ADDENDUM NO. CC-1

August 1, 2014

Northeast Community College
NECC Extended Campus – O’Neill, NE
505 East Highway 20
O’Neill, NE 68763
BCDM Project No. 3529-02

DRAWING REFERENCED:	S1-1	ATTACHMENT	SDS-03
DATE/TIME:	8/4/2014 2:51:05 PM

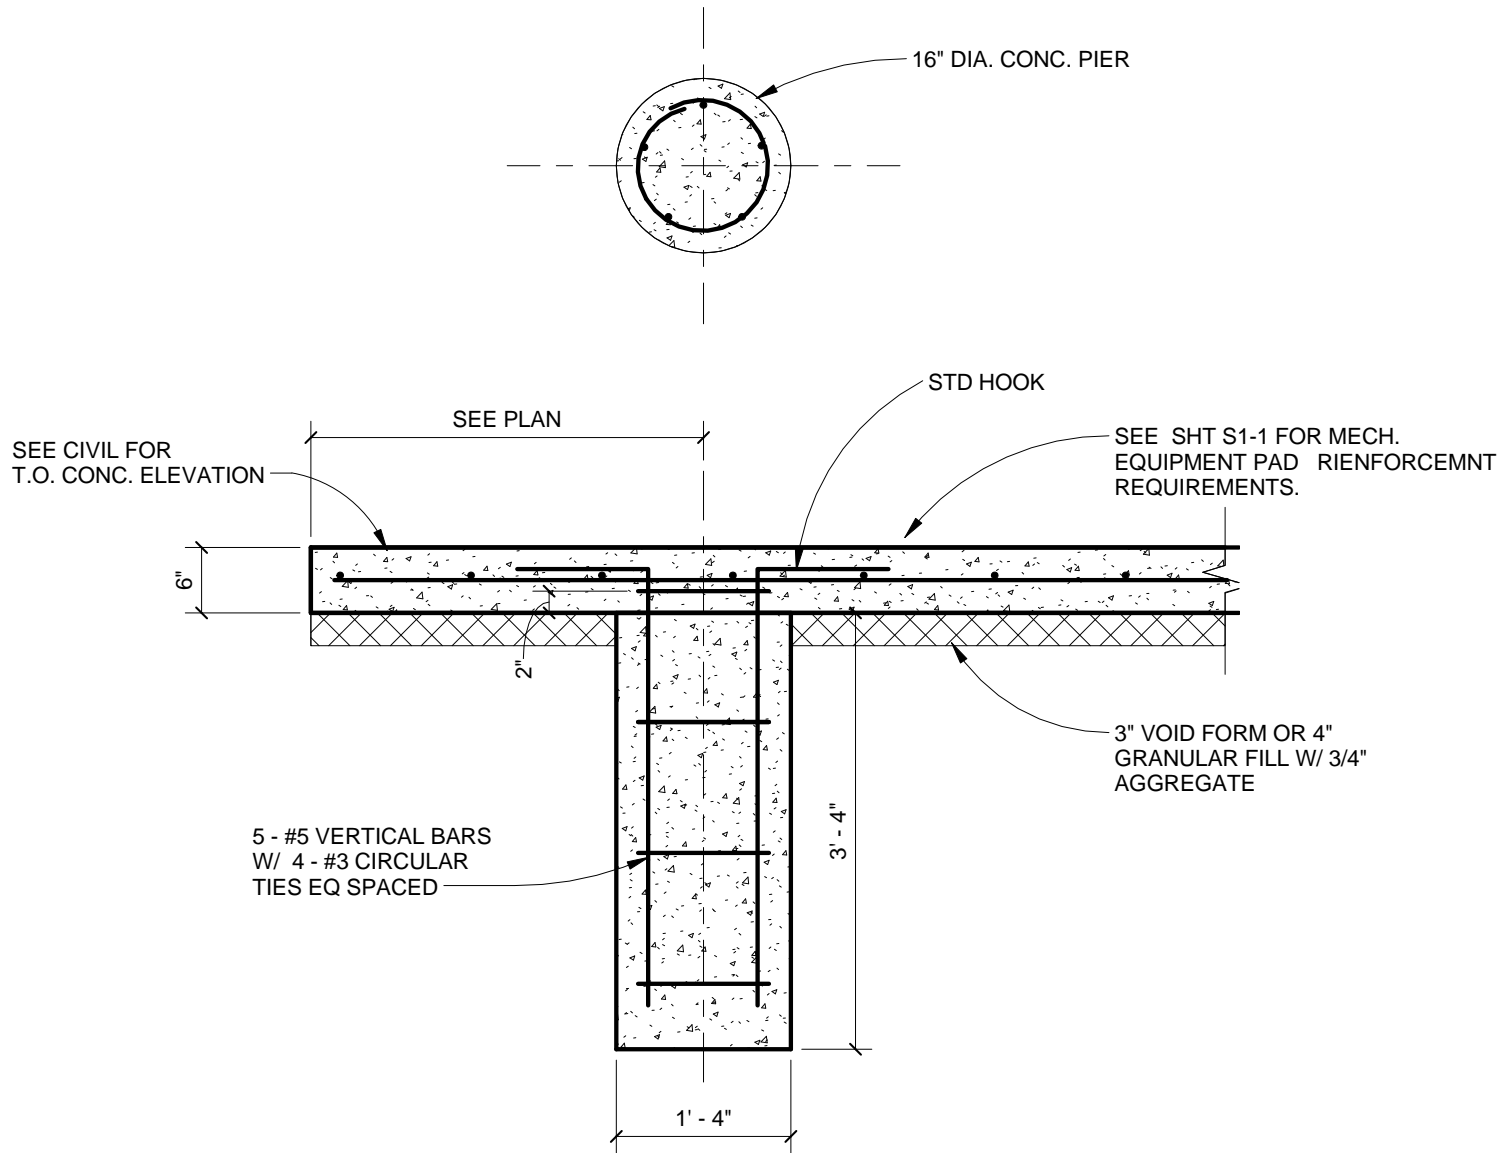
1. Column grids for conventional classroom building shall be based on architectural sheet A1-1.
2. Add two new footings supported on 16-inch diameter concrete piers for exterior mechanical pads per sheets SDS-01, SDS-02 and SDS-03.
